Coleman Revitalization Advisory Board

Report to Mount Pleasant Mayor and Town Council

February 28, 2007

street framework

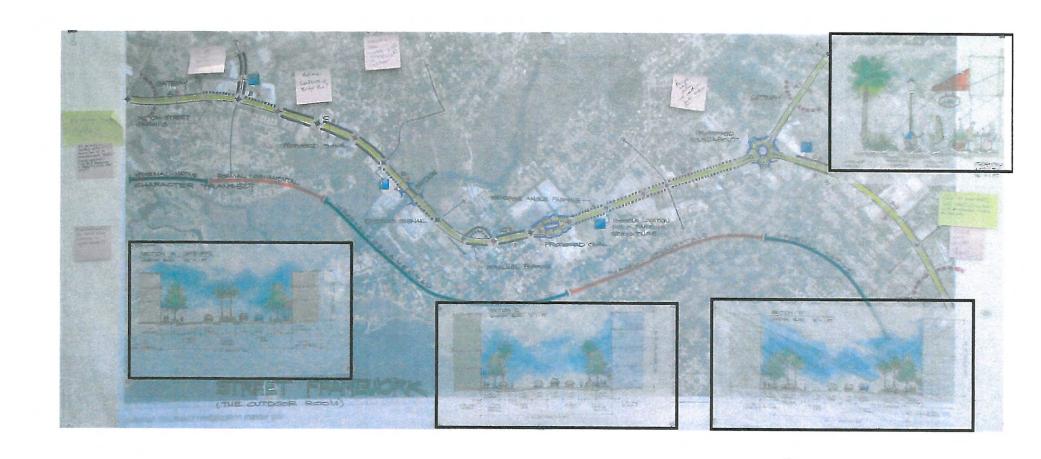
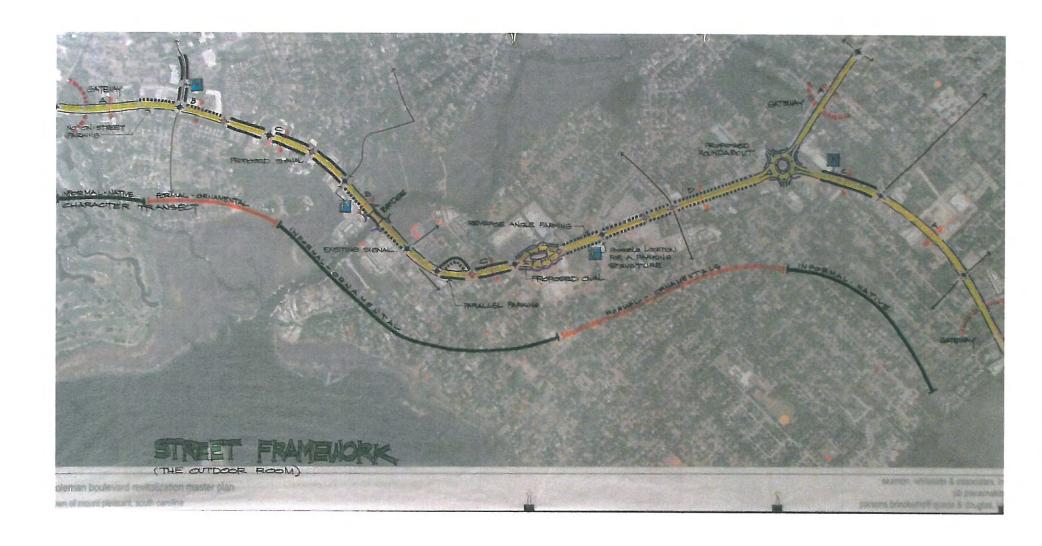
Seamon Whiteside and Associates (SWA) proposed in their conceptual plan (Exhibit C) a large roundabout as a solution to the intersection's deficiencies. While the CRAB agrees that SWA's roundabout solution makes sense, the roundabout illustrated is too large, encroaching too much on private land and surrounding businesses. The CRAB also believes that the illustrated roundabout, with its need for right of way acquisition, pedestrian tunnels, and a park feature, would be too costly and, if constructed, would require an unnecessarily large outlay of public funds.

The CRAB recommends that a smaller roundabout be considered by the Town; one that can be configured within the existing right of way, that allows for improved pedestrian and vehicular traffic flow, and that provides better ingress and egress to surrounding businesses.
